Subject: ELECTRICAL DEVICES CANNOT BE CHARGED AT REAR CONSOLE OR TRUNK SIDE TRIM USB POWER OUTLET	Bulletin No.: 09-013/23
	Last Issued : 02/16/2023

2016-2023 CX-9 vehicles with VINs lower than JM3 TC**** ** 630018 (Produced before Aug. 1, 2022)

Rear Console

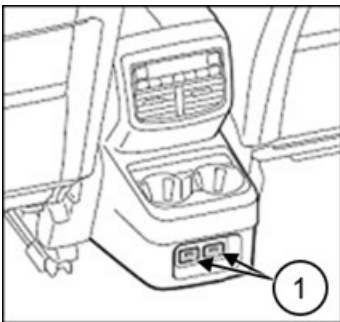
1. Verify the customer concern.
2. Replace the USB power outlet (1) on the rear console or trunk side trim with a modified part according to the instructions on MGSS online: (USB POWER OUTLET REMOVAL/INSTALLATION)
